From: Mary Elizabeth <mebeth@outlook.com>
Sent: Tuesday, January 21, 2025 11:30 AM
To: Rodriguez, Melanie
Subject: 1.21.2025 Non-agenda Comments
Attachments: GSFA_DEIR_Comments_1.20.2025_ME.pdf

Re: **GSNR DEIR Comments** Wood Pellet Export Project aka Forest Resiliency Demonstration Project EIR

From: Vaughan Frost, Rita <rfrost@nrdc.org>
Sent: Tuesday, January 21, 2025 11:48 AM
To: Rodriguez, Melanie
Cc: gloria@littlemanila.org; matt@vip209.org; Ector Olivares; Julie Dunning; Mary Elizabeth; Barbara Barrigan-Parrilla; Hammel, Debbie; swolf@biologicaldiversity.org
Subject: 1.21.2025 Non-agenda Comments
Attachments: Final Joint DEIR comments on GSNR wood pellet project 1.20.25.docx (1).pdf; Final GSNR DEIR Comment Letter.pdf

FIGURE 2-1

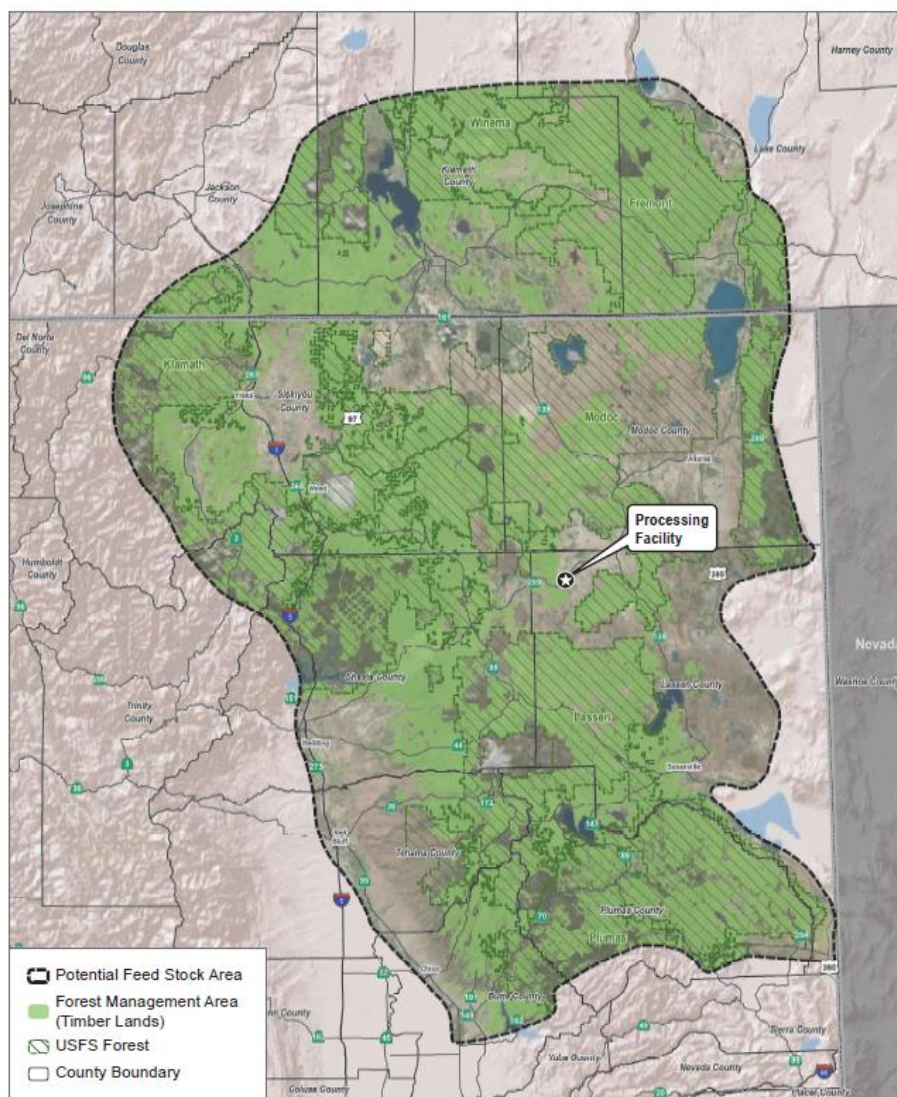
Feedstock acquisition. The feedstock acquisition areas for the Project are depicted in DEIR Figures 2-1 (Lassen Facility area) and 2-2 (Tuolumne Facility area). The Lassen Facility feedstock area comprises 26,185 sq miles, and the Tuolumne Facility 16,668 sq miles. The distances from the proposed production sites to the farthest edge of the feedstock area are 120 miles for the Lassen Site and 159 miles for the Tuolumne site.²⁴⁸ The “modified treatable areas” containing the desired tree species within each feedstock area tend to be near the edges of the area, not clustered near the pellet mill sites.²⁴⁹
